SUBJECT: 1977 Annual Report on the Space Shuttle

NASA's Response to Comments
made in the
Aerospace Safety Advisory Panel Annual Report
on the Space Shuttle Program
dated March, 1977

Recommendation: 2, page 27

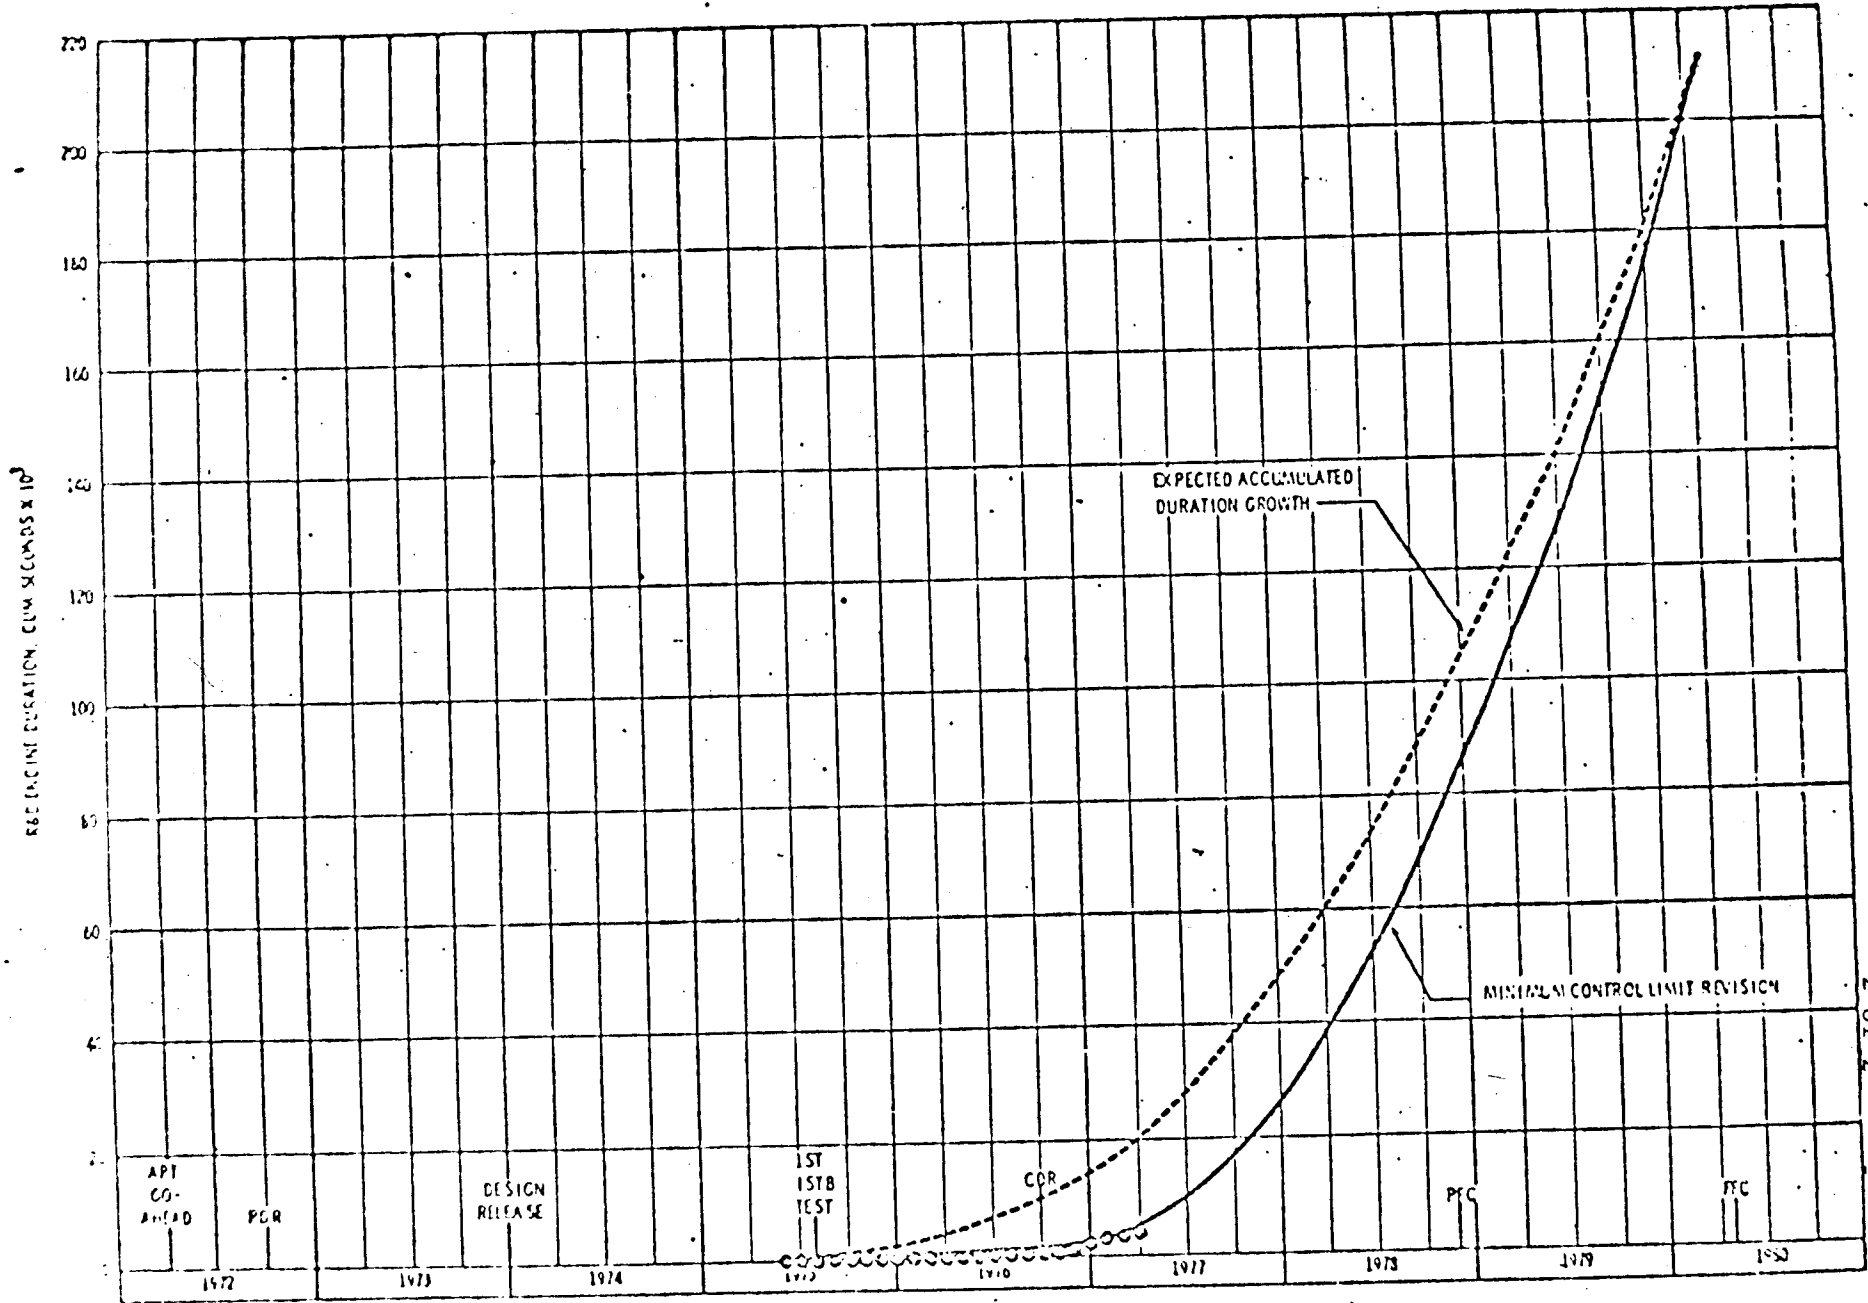
Recommendation: "2. If these requirements are not met in a timely fashion the program will, of course, face important judgments as to how to guarantee the necessary test time to certify the engines for manned orbital flight. As noted in last year's Annual Report, the planned test program called for fifty-six hours of engine testing in Final Flight Configuration which compares favorably with the test time accumulated on the Saturn F-1 and F-2 engines. Contingency or recovery planning must provide management either the realistic schedule to meet such an objective or the significance of any deviations from that goal in term of the effect on the basis for confidence in the flightreadiness of the engine."

Conclusion: SSME test planning has been adjusted to accomplish the necessary goals prior to First Manned Orbital Flight (FMOF) as well as Final Flight Certification (FFC). An "Accumulated Run Duration" plan (attached) has been established and Project progress is reviewed with MSFC Center Management and Space Shuttle Program Management. In particular, the test progress is reported monthly in the Monthly Director's Review to Dr. Malkin and the progress of the SSME Project against this plan should be used to assess the progress.
